Refer to: HSA-10/WZ-150

This is in response to your email message of January 29, 2003, requesting Federal Highway Administration (FHWA) acceptance of your company's URHT Type III barricades as crashworthy traffic control devices for use in work zones on the National Highway System (NHS). Your email message transmitted drawings of the barricade. You requested that we find these devices acceptable for use on the NHS under the provisions of National Cooperative Highway Research Program (NCHRP) Report 350 "Recommended Procedures for the Safety Performance Evaluation of Highway Features."

URHT Type III barricades

SafetyCor Plastic Sign Panel
Mounted on Plastic Supports

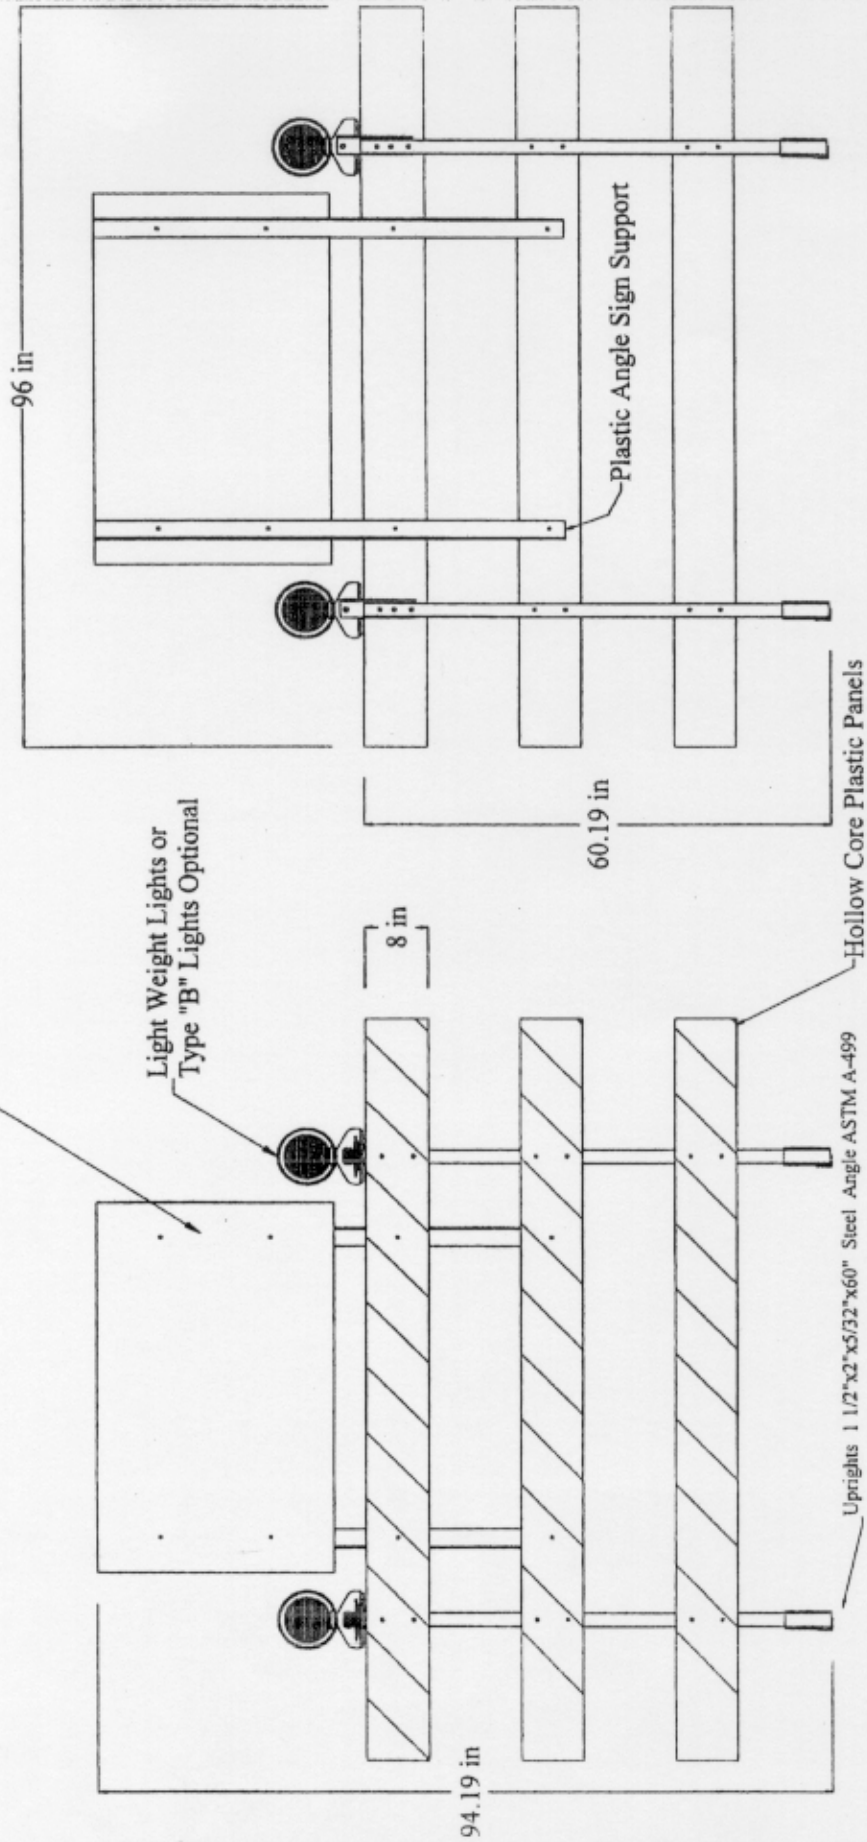
You also requested the optional use of a lightweight substrate sign panel mounted above the top rail. The sign would be mounted on plastic angle uprights and fastened to the top two barricade rails. The plastic angle uprights measure 1.87 inches x 2.15 inches x 60 inches long. As the mounting height is sufficient to keep the top of the sign from impacting a small car's windshield we concur in the use of signs mounted on your barricade as you described.

8' Plastic Type III with
SafetyCor Plastic Sign
and Lights

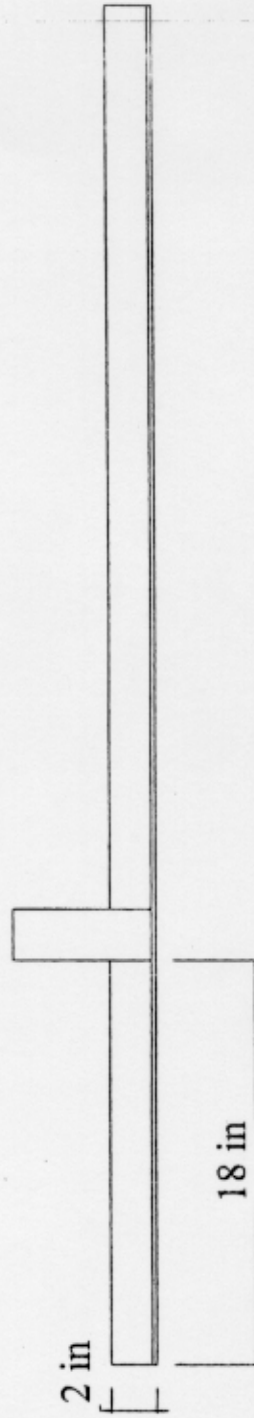
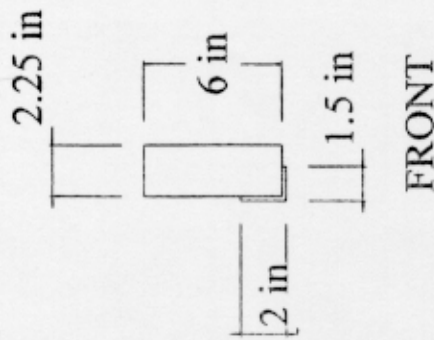
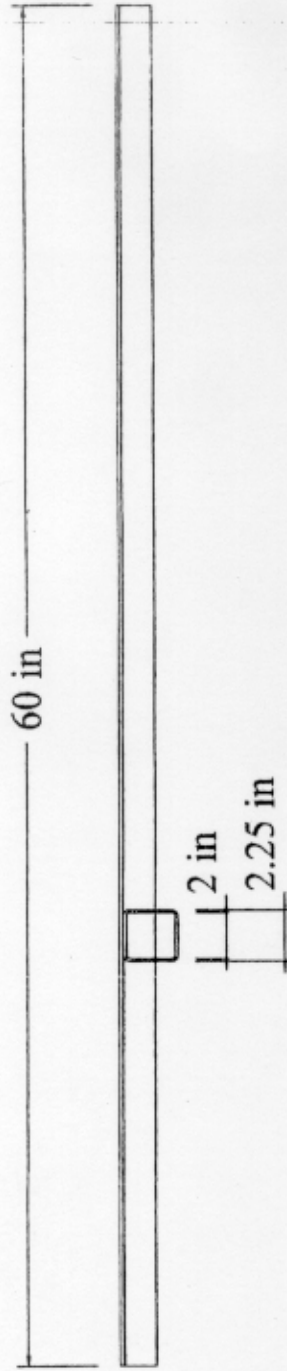
This barricade consists of 2.0 x 1.5 x 5/32 inch by 60 inch long steel angles as skids. To these skids are welded 6-inch high sockets. The vertical uprights are 2.0 x 1.5 x 5/32 inch steel angles made of hot-rolled ASTM A-499 steel. They are 60 inches long and are inserted into the sockets with no hardware fastening them in place. The barricade rails are 8-inch wide by 8 feet long hollow core plastic panels manufactured by Bunzl Extrusions. They are fastened to the uprights using 3/8-inch hardware. The various components have been found acceptable in FHWA Acceptance Letters WZ-40, WZ-85, and WZ-117. We concur that these components will be acceptable in the structure you have designed.

You also requested the optional use of one or two lightweight warning lights, as were found acceptable in our letters WZ-54 and WZ-63. We concur in the use of these lights.

You also requested the optional use of an Empco-Lite Model 212 Type B warning light. These were crash tested on generic Type III barricades by Empco-Lite and were accepted for use in our letter WZ-49. We concur in the use of these lights with your barricade.
